HARTING Product Change Notification

PCN/19/003/C+N

Product range: Han / Han-Modular

Title: Han PE Module surface treatment - External.docx

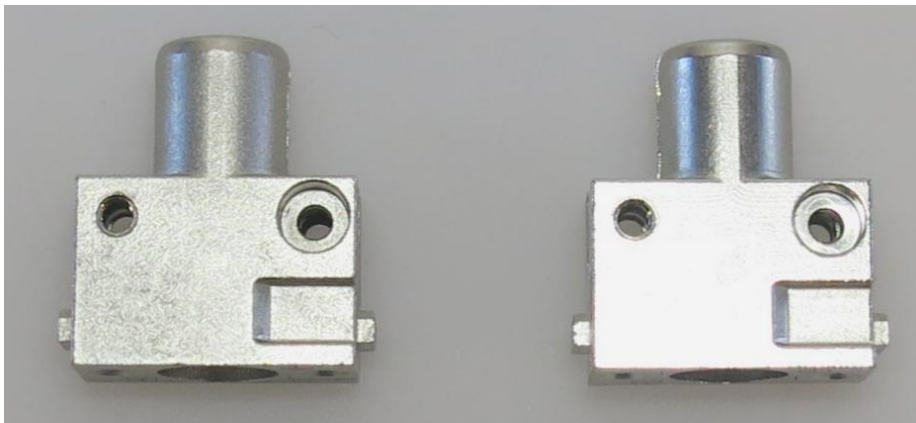
We are going to change the surface treatment of the die cast zinc shell from sand blasting to vibratory grinding before the coating.
